# Newsletter

07.2021

Knott K27 Couplings

**K27-A  
S-250kg**

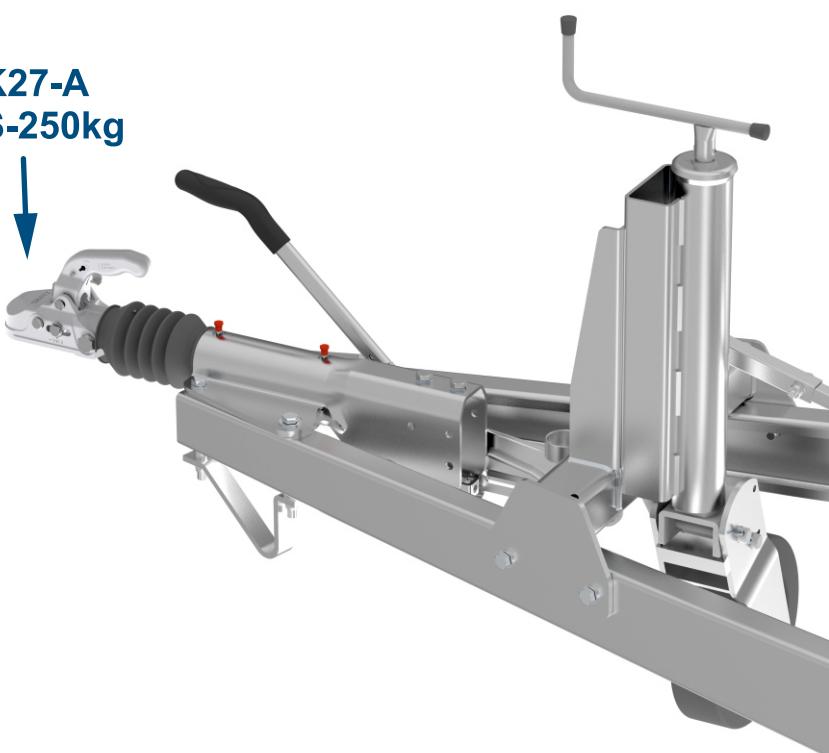
We would like to inform you that the K27 coupling head has been modified and tested by a certification body so that increased was permissible vertical load on the ball to 250kg.

The introduced de-identification is connected with the change of the approval number, which results from the new provisions introduced in the ECE R55 regulation (version 02).

K27 coupling heads are now characterized by the permissible pressure on the S-250 kg ball.

**In connection with the change, the approval number also changes, and thus it will require you to take into account the discussed change in the FTL approval.**

E1 55R-02 2122  
B50X S-250kg  
D/DC 25.00  
DMC 2700kg
